STATE OF NEW HAMPSHIRE SITE EVALUATION COMMITTEE

RE: Application of Antrim Wind, LLC for Certificate of site and)
facility to construct up to 28.8 MW of wind electric generation)
in the Town of Antrim, Hillsborough County, New Hampshire)
and operate the same (SEC Docket # 2015-02).)

PRE-FILED DIRECT TESTIMONY OF RICHARD BLOCK

Detail of Exhibit 11: Crotched Mountain Summit Trail

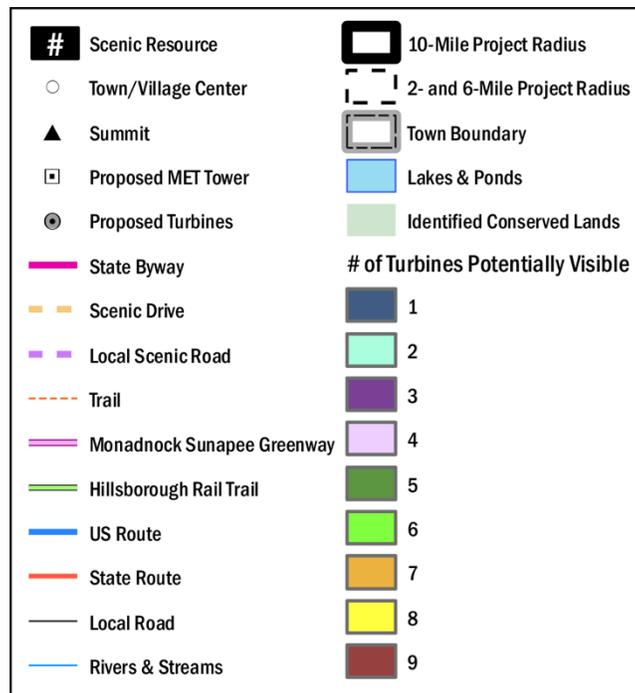
Unless base photographs are taken carefully observing the rule previously mentioned which specifies “clear weather conditions”, the resulting simulation will require an excessive amount of aerial perspective qualities applied. This will then appear as if a “haze or fog effect” has been employed. This will deceptively make the turbines much less visible as if their visual impact was far less. Avoiding this situation was the rationale for the Site rules to plainly require clear days with optimum visibility and no haze or fog. In the case of Exhibits 7 and 11 in the VA (Franklin Pierce Lake and Crotched Mountain Summit Trail), the base photographs were taken on extremely hazy days making it necessary to apply an excessive amount of aerial perspective qualities to give the turbines some sense of realism in that setting. This results in them being almost invisible:

Same map using LandWorks viewshed map color keying

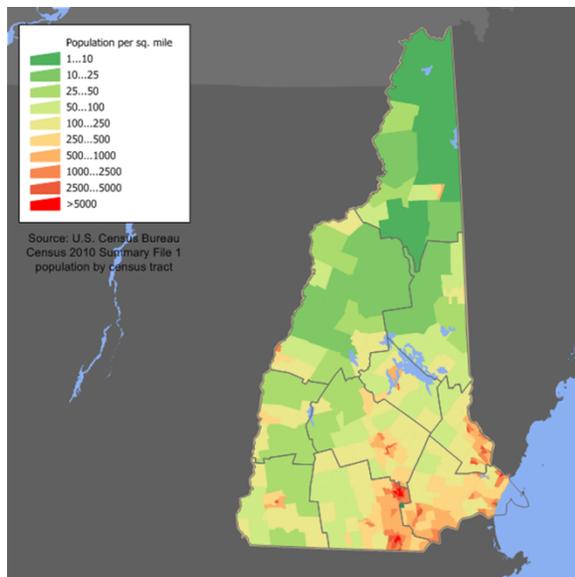
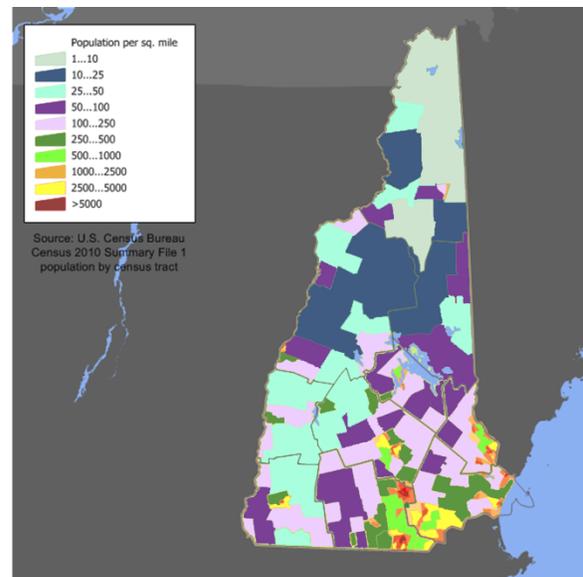
The major problem with the coding system used on these viewshed maps is that they have no logical basis in how the colors have been assigned. It can be seen in the map key above that the table of color swatches assigned to turbine visibility, while arranged in numerically ascending order, has no pattern or predictability in the arrangement of hues. Spectral color and lightness or darkness value have no pattern. The color swatches are assigned in a totally random fashion. Value (or relative lightness or darkness) is a common way that the eye groups colors, yet the values of these swatches are so haphazardly arranged that the swatches for 8 turbines, 2 turbines, and the color assigned to “Identified Conserved Lands” have equal impact on the maps. The colors assigned to 9 turbines and 3 turbines are so similar in value as to be difficult to separate on the maps. Absolutely no patterns of turbine visibility can be detected from the color coding on any of the viewshed maps.

For the sake of illustration I altered the same map to use instead the random color scale from the viewshed maps in the same order and applied those colors to their appropriate regions. The result is a map with no discernable pattern, no informative trends which convey to us a deeper meaning of the data when applied over the geographic distribution. It is a random patchwork which would require a lot more work on the part of the viewer to understand. See the map on the right:
